Dye House

Design & Access Statement - Planning Consultation Addendum

Addendum Document

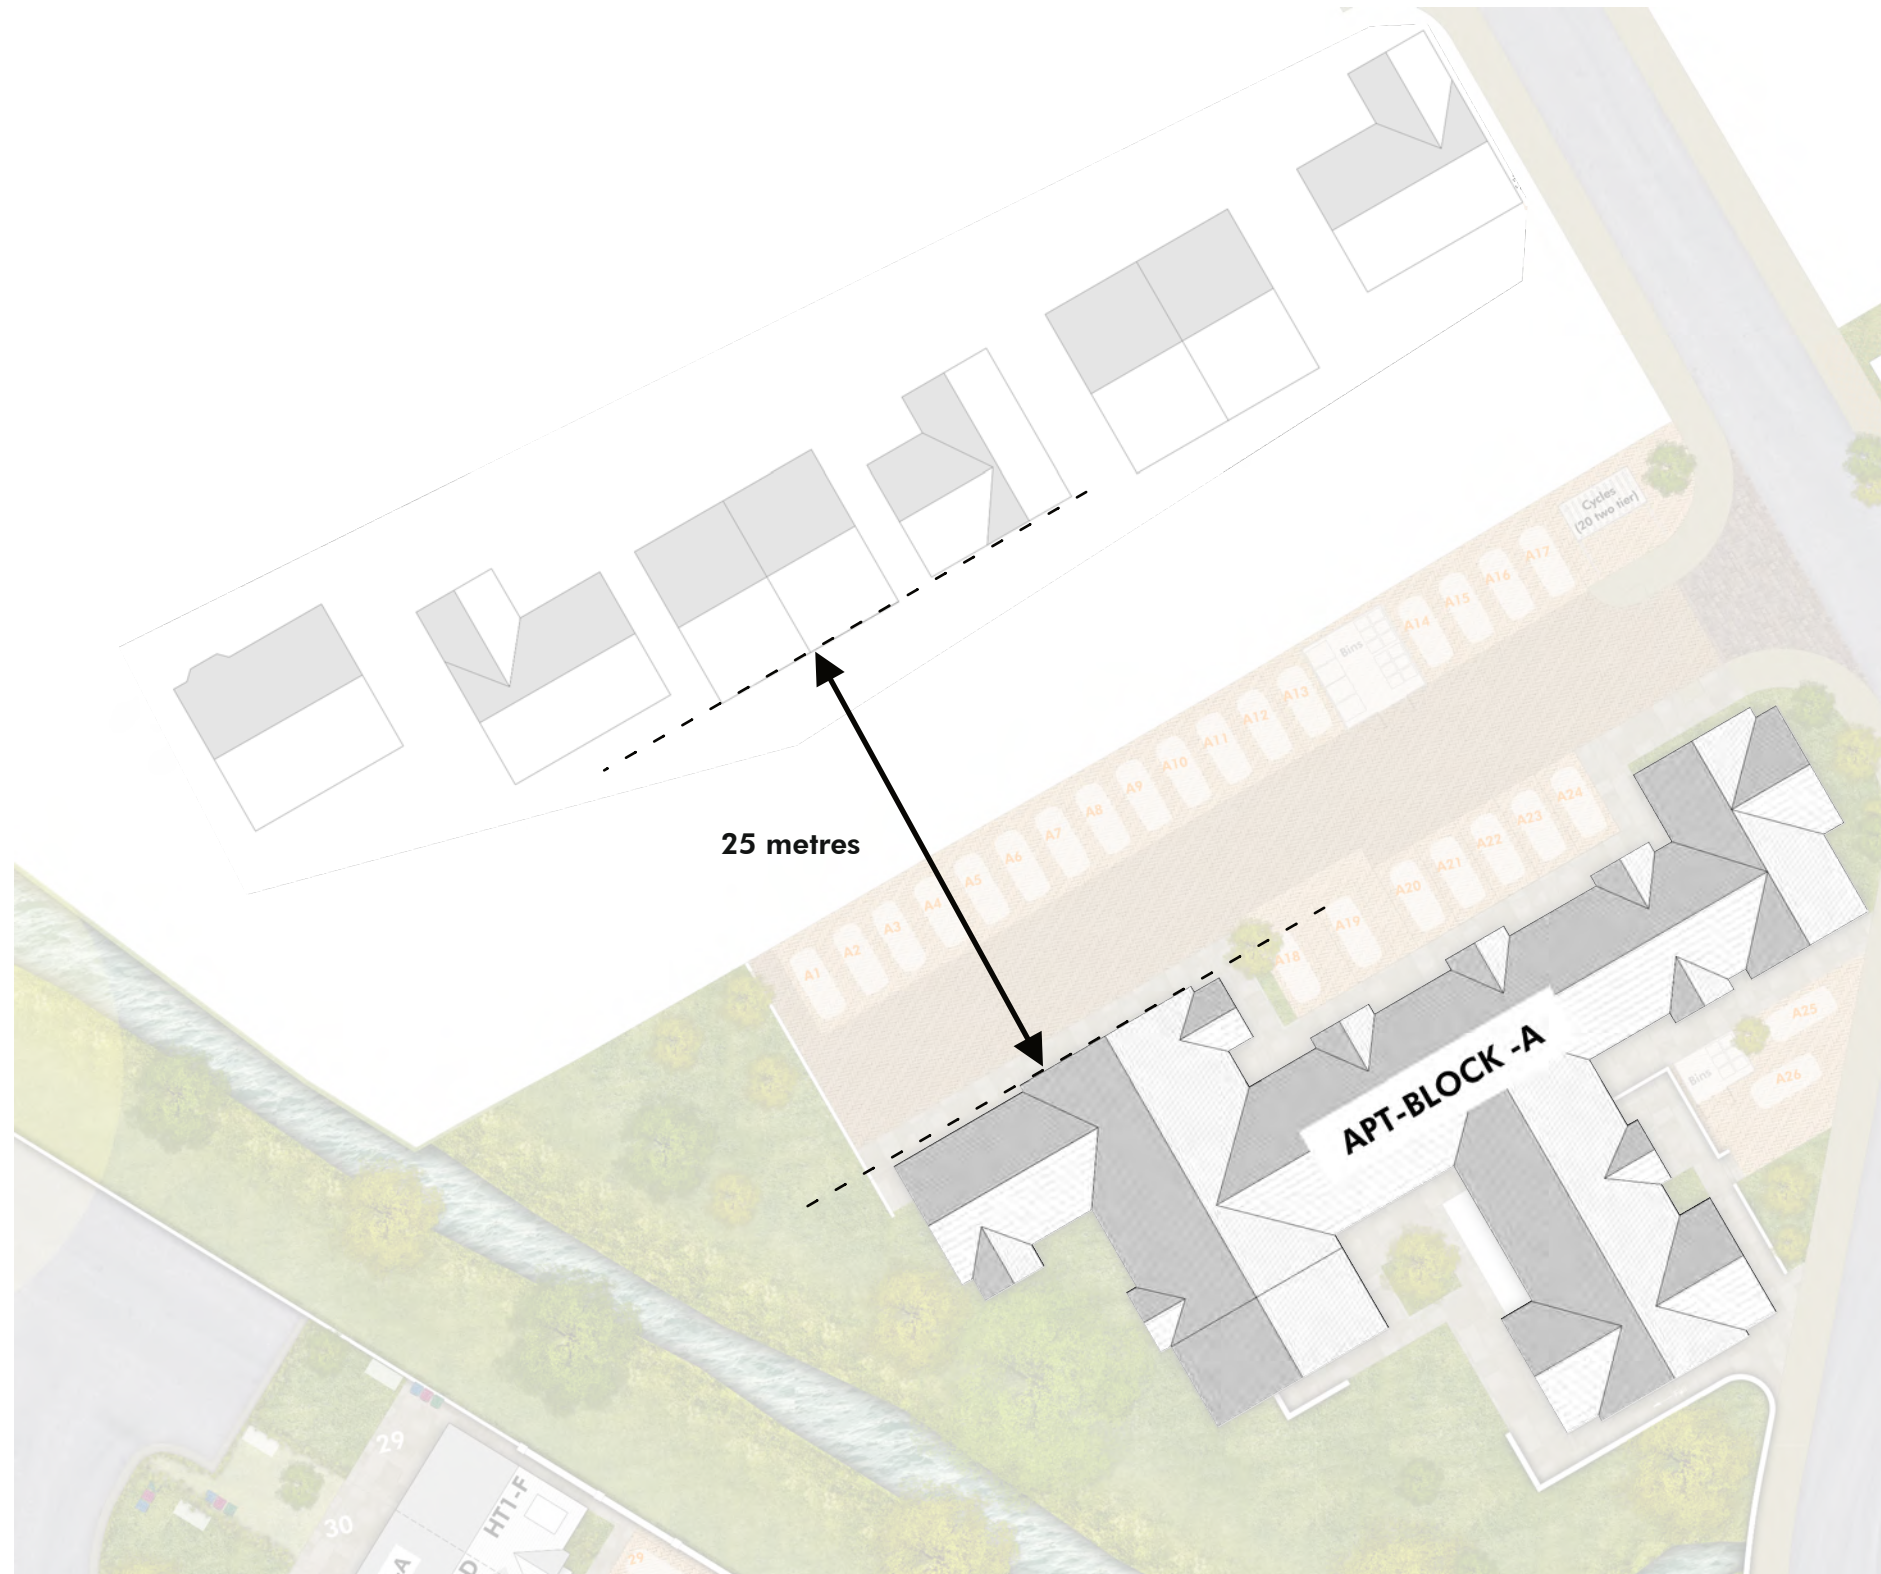
The Planning Officer raised concerns that this could in-fact be deemed a Principle Elevation and would therefore require a minimum distance of 25metres.

We had numerous discussions to illustrate how this was not the case for a number of reasons. We also undertook several design iterations to further mitigate any potential impact on the neighbouring Taylor Wimpey scheme. Design changes in these iterations included the removal of any key architectural features from the facing elevation, and the reduction of the ridge height by 1 metre to further lessen the impact on the TW scheme.

In spite of these design alterations, it was not accepted by the Planning Officer that this constituted a Non-Principle Elevation. As a result, we have redesigned the scheme to accommodate a 25m interface distance between Block A and the neighbouring Taylor Wimpey Scheme. The reduction in the ridge height remains in place.

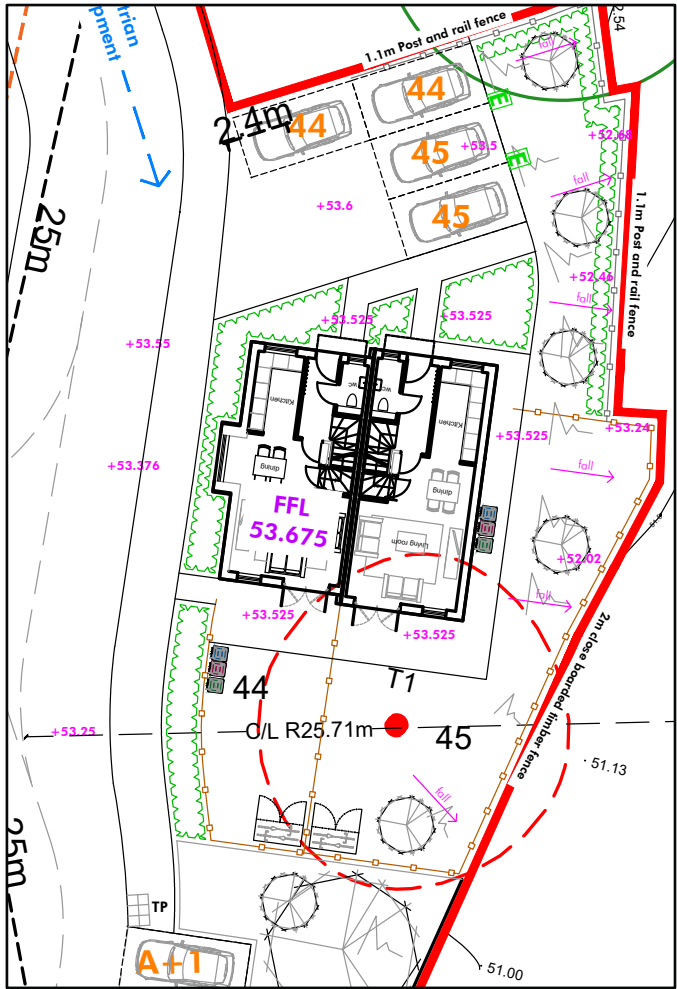
The initial proposal showed units on plots 44 and 45 at the North-East corner of the site. The design team believed that the 17m interface distance between the rear elevation of the houses on plots 44 and 45, and the side elevation of the neighbouring property of the then-proposed Taylor Wimpey Scheme (16 Walnut Grove) was sufficient.

Now built, and with the side elevation of 16 Walnut Grove clearly constituting a Principle elevation, the design team acknowledged an interface distance of 17m with the principle rear elevations of plots 44 and 45 would not be suitable.

Design Iteration A

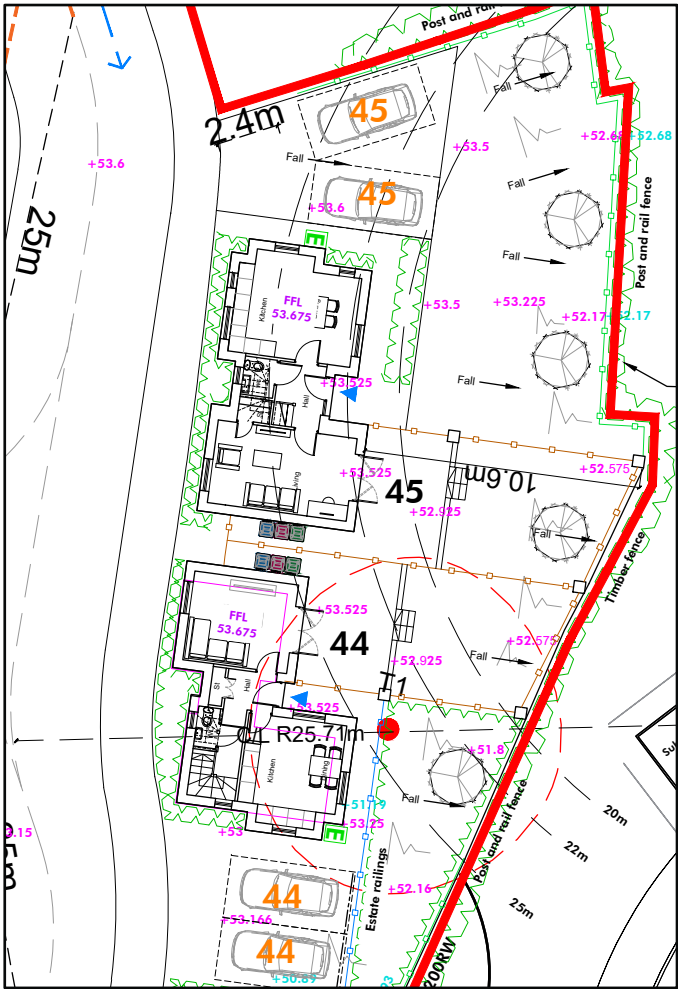
The design team undertook several iterations, including reorienting the houses on plots 44 and 45 to ensure that the facing elevation was non-principle (See Iteration A).

It was then brought to light by the planning officer that the Planning Policy stipulates that any developments in SUE sites must make concerted efforts to ‘address’ one another. It was deemed that the non-principle elevation was not meeting this criteria.

Further design iterations were undertaken, including Iteration B (left), whereby the units were split into two detached units, achieving 25m interfacing distances from 16 Walnut Grove. These units were also designed to address the neighbouring development by fronting onto the Public Open Space of the Taylor Wimpey scheme, whilst also addressing the highway within Dye House. We believe that these design alterations meant that the North-East corner was therefore in line with the planning policy.

However, following these design changes, the Planning Officer informed us that that there was a desire for a ‘Green Corridor’ to run North-South through the Taylor Wimpey scheme. They explained that housing in this location would not enable residents of both Orchard Park and Dye House to fully enjoy the benefits of the Green Corridor.

As a result, the two houses at the North-East corner of the site (formerly plots 44 and 45) have been removed from the scheme. The resulting open space grades down to meet the level of the adjacent land to create a seamless integration between the two sites. By extending the Green Corridor into our site, residents of both developments can now enjoy more public open space.

Final Amendment

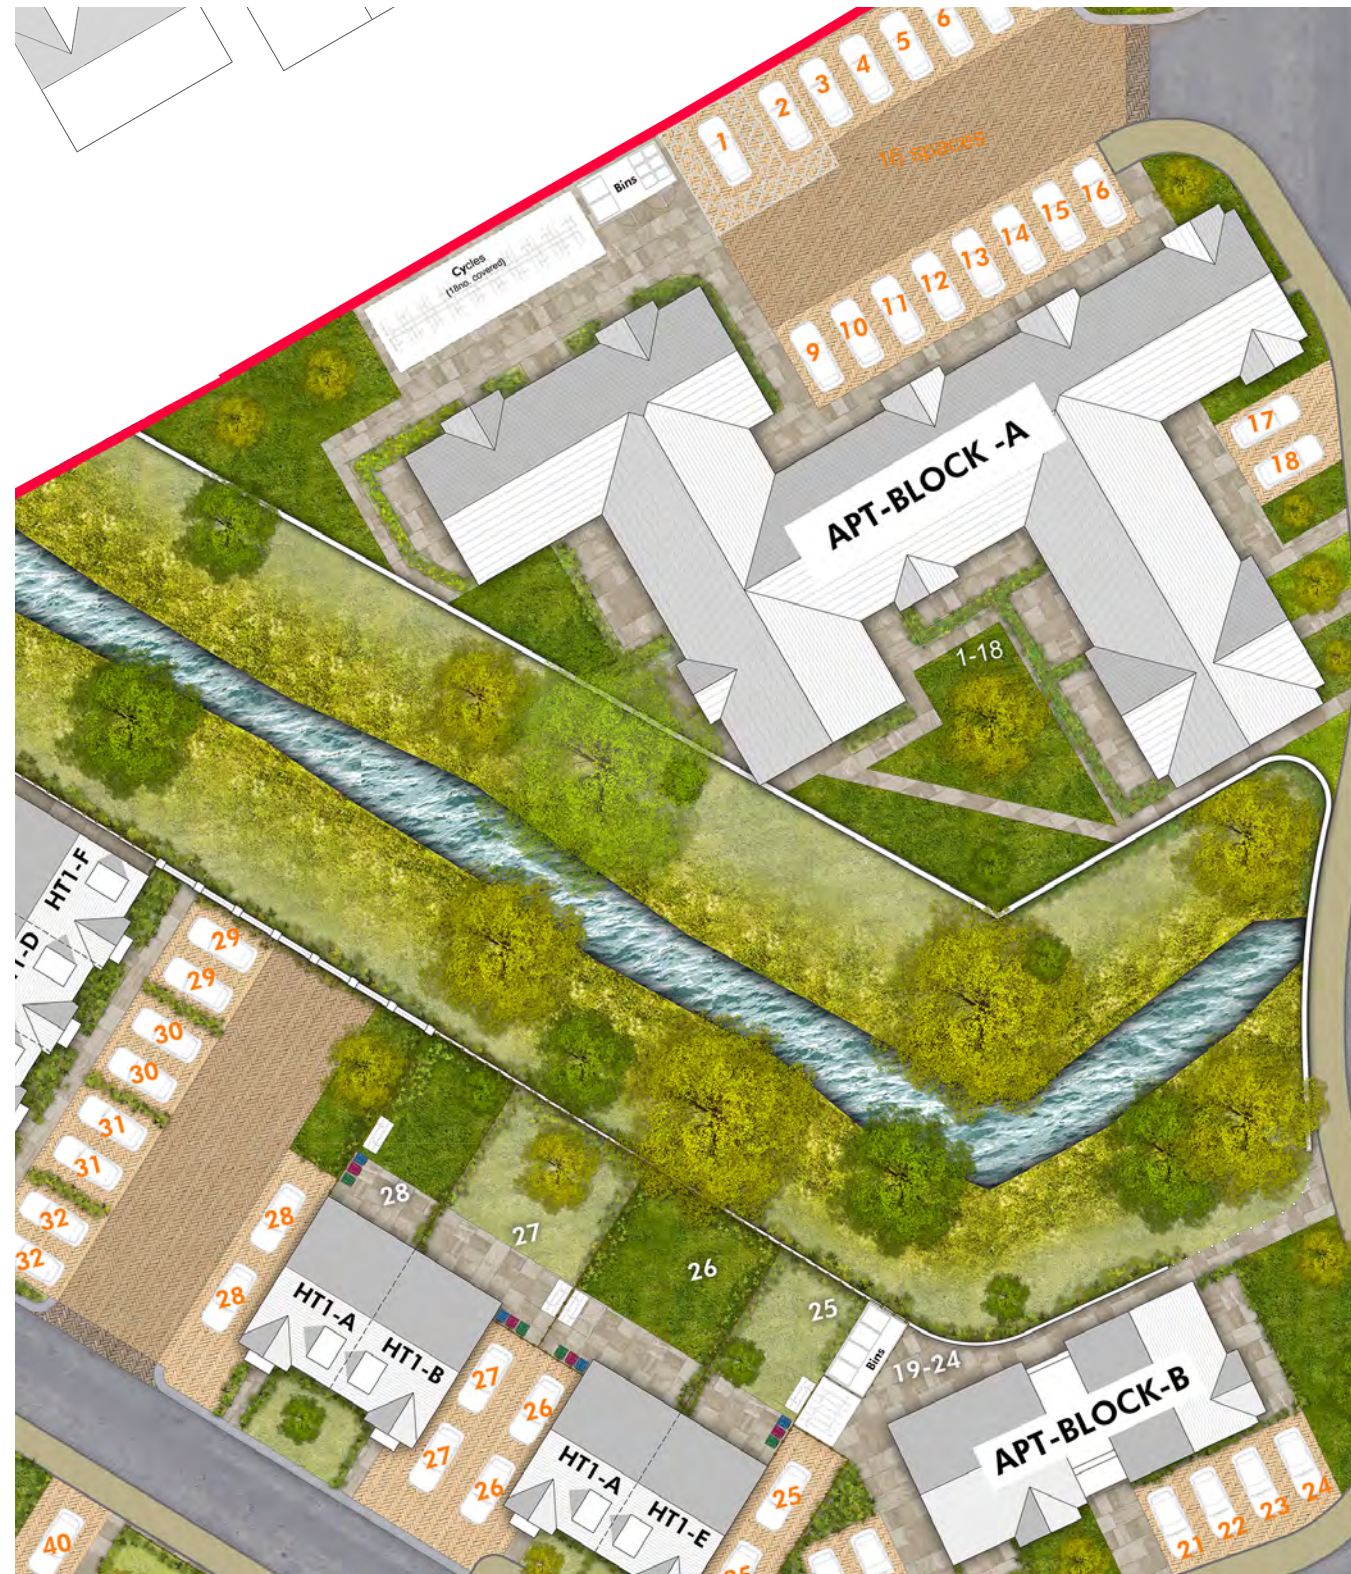
The initial proposal showed a 6m high acoustic barrier fence at the position shown on the site plan.

At the meeting on the 23rd November 2023 they proposed that we explored the possibility of lowering the fence height. The Planning Officer stipulated that further noise modelling should be undertaken to assess the acoustic performance of different fence heights.

We presented the findings of the further noise modelling for fence heights of 2 metres, 2.5 metres and 3 metres.

Based on these findings, the Planning Officer agreed to support the inclusion of a 2.5 metre high fence.

The initial proposal showed a 6m high acoustic barrier fence. Following further noise modelling, the Planning Officer has agreed to support the inclusion of a 2.5 metre high fence.

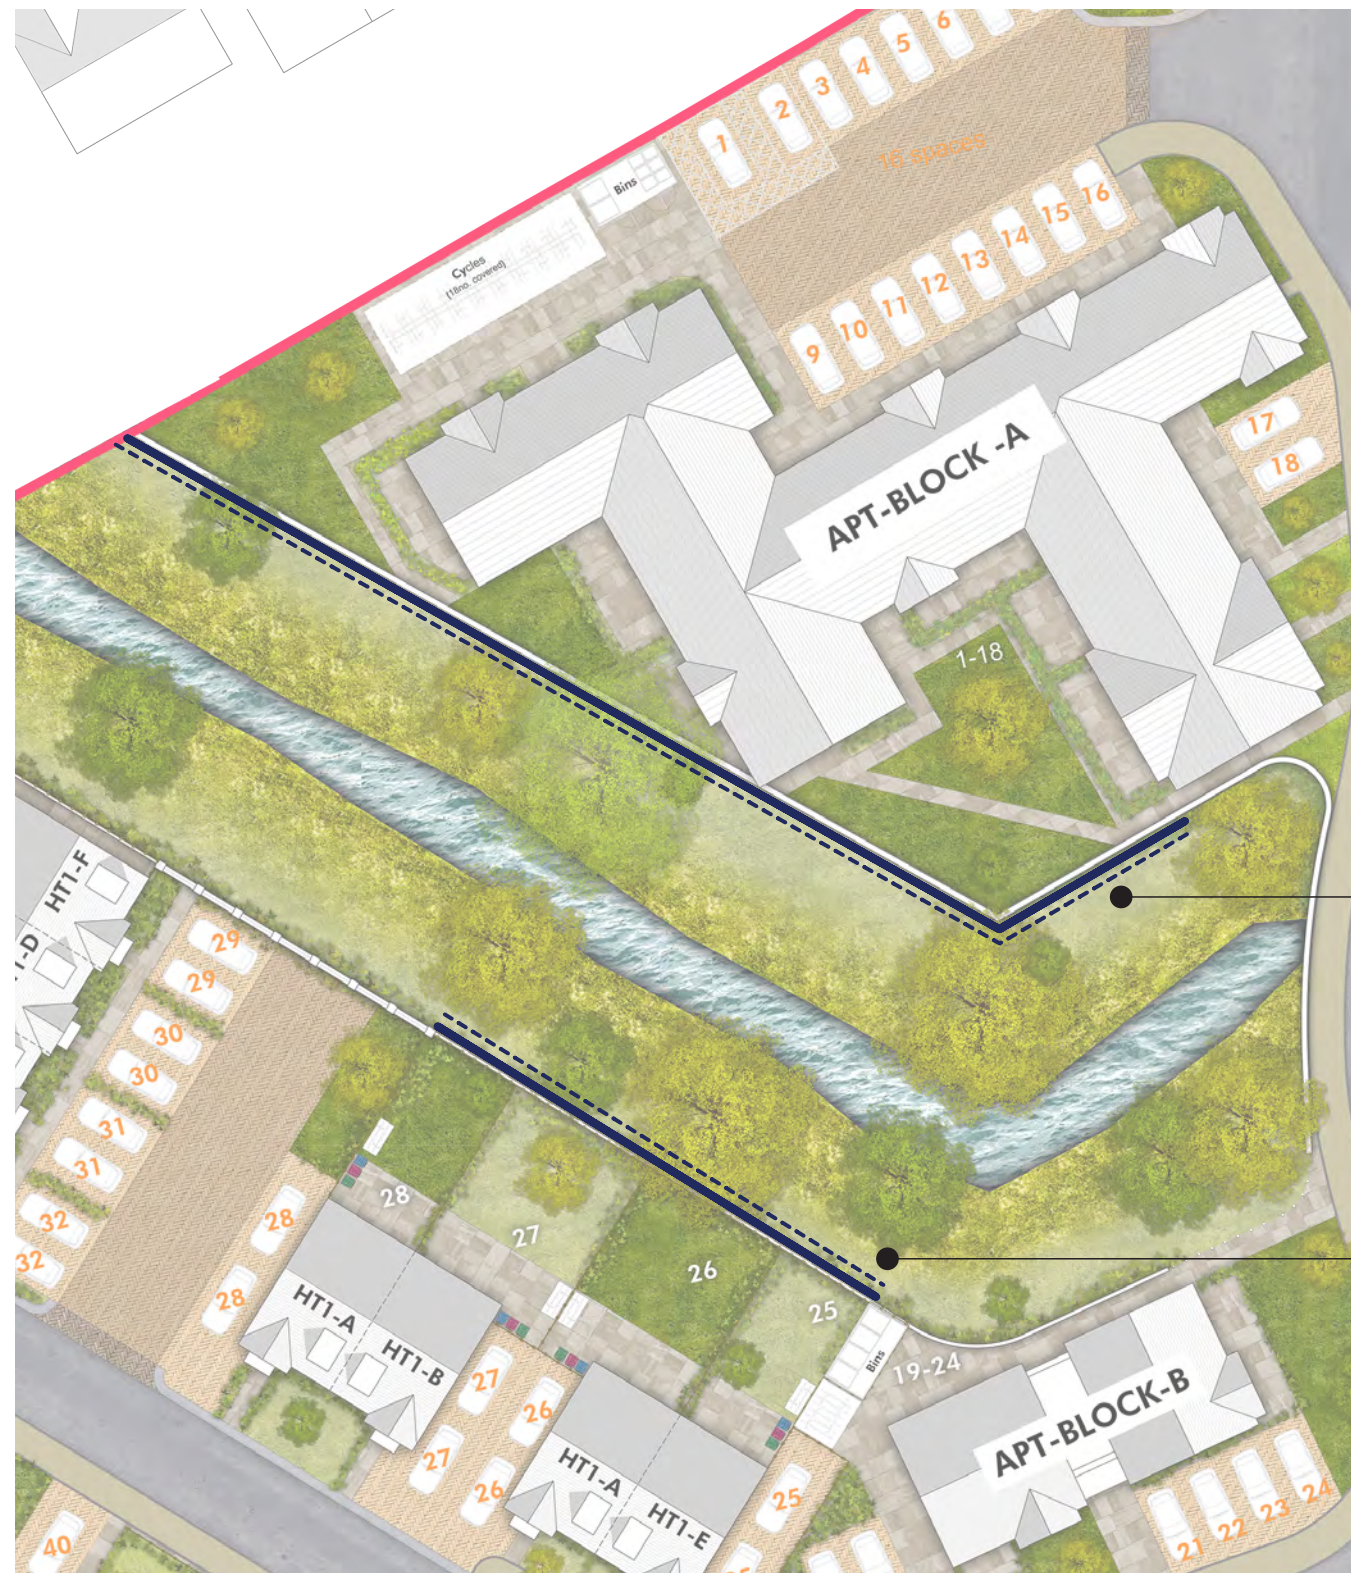
The Planning Officer's feedback was that the scheme should strive for better integration with the Brook, in line with the EA's goal to enhance public access to the nation's waterways.

Railings along the communal gardens shown in the initial proposal provided a visual connection to the Brook, but integration was limited by the change in level between the Brook and the Communal Gardens.
